LAKE HAVASU CITY

**HAVASU 280 INFRASTRUCTURE CONSTRUCTION
PROJECT NO. PR2070
ADDENDUM NO. 1
July 13, 2016**

Submitted Bid Questions (Q) and Responses (R)

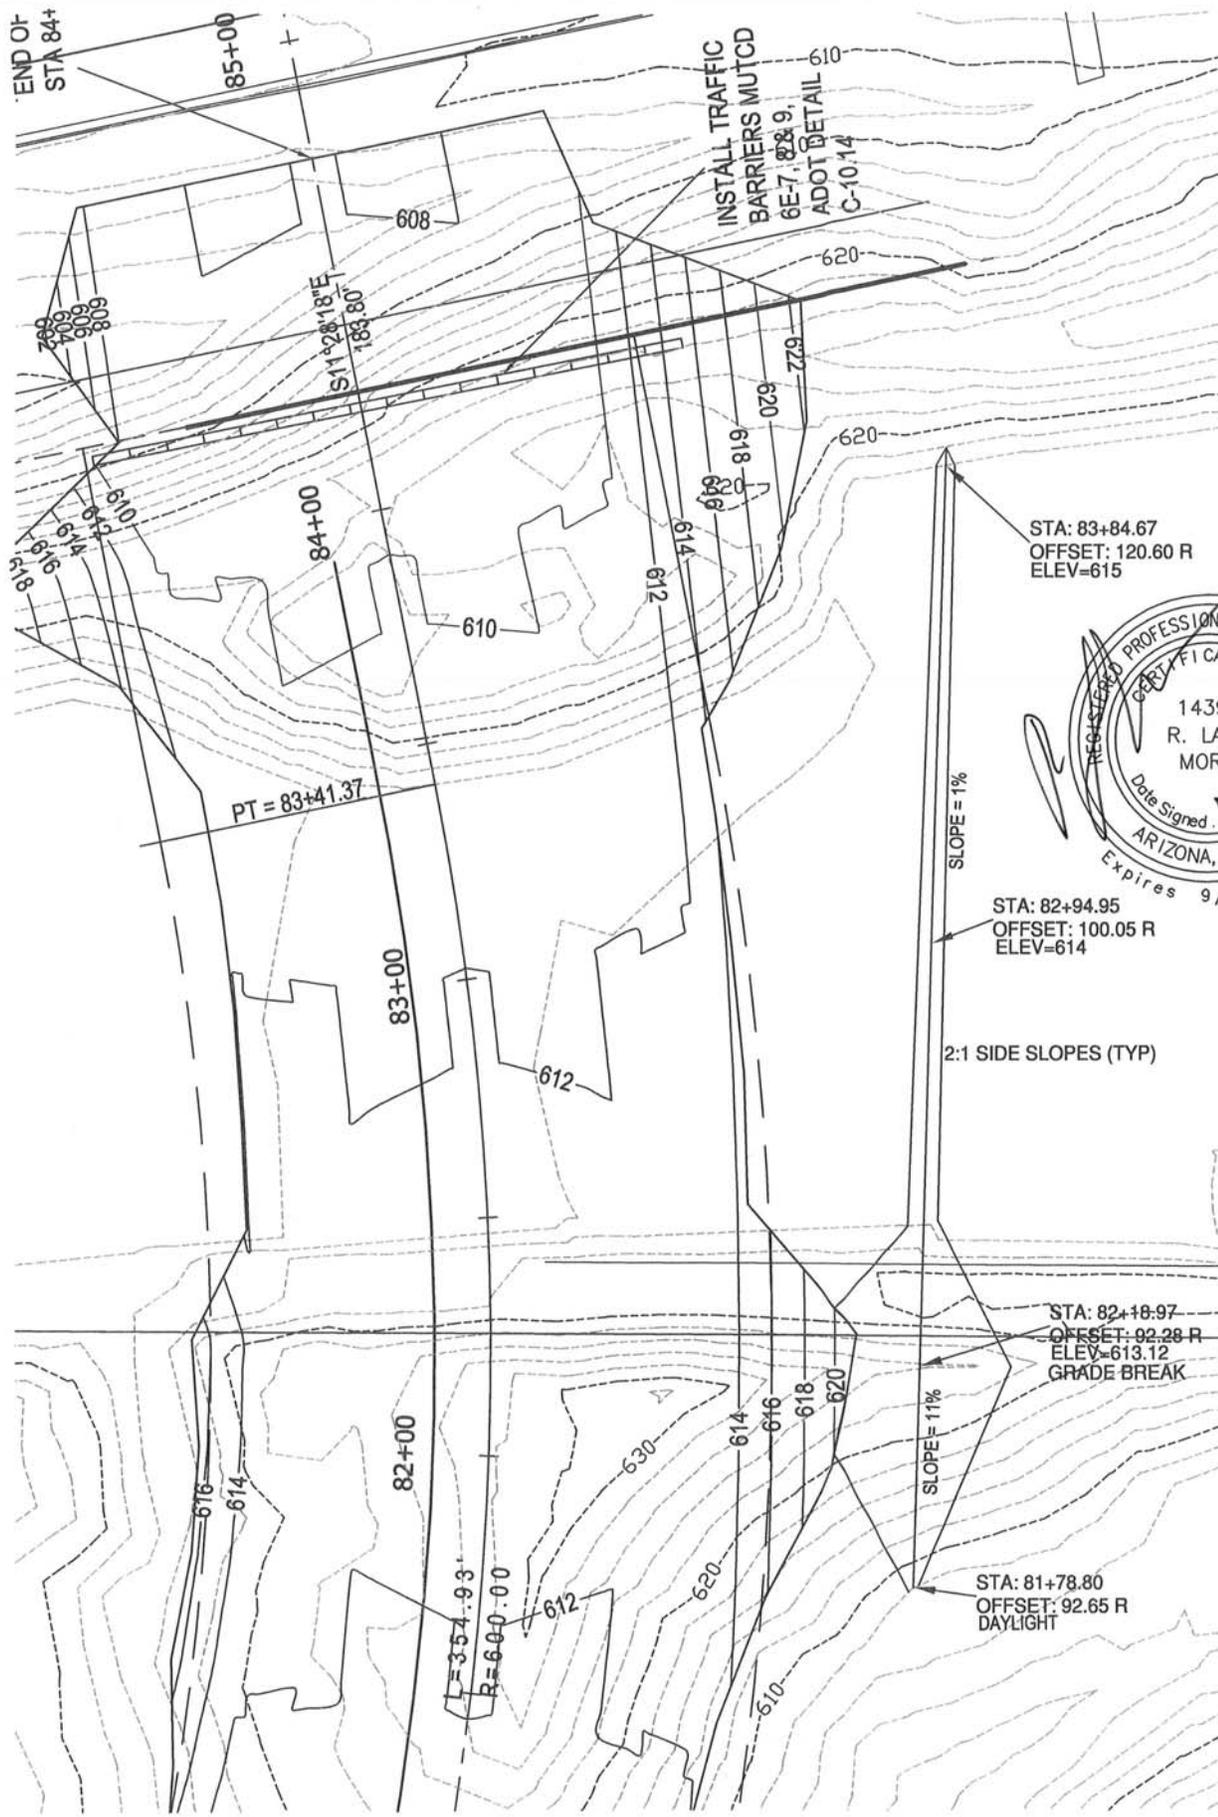
Q6. Will there be a drainage structure to prevent the run off from the new road entering SR95?

R6. *Please see attached sketch for ditch addition.*
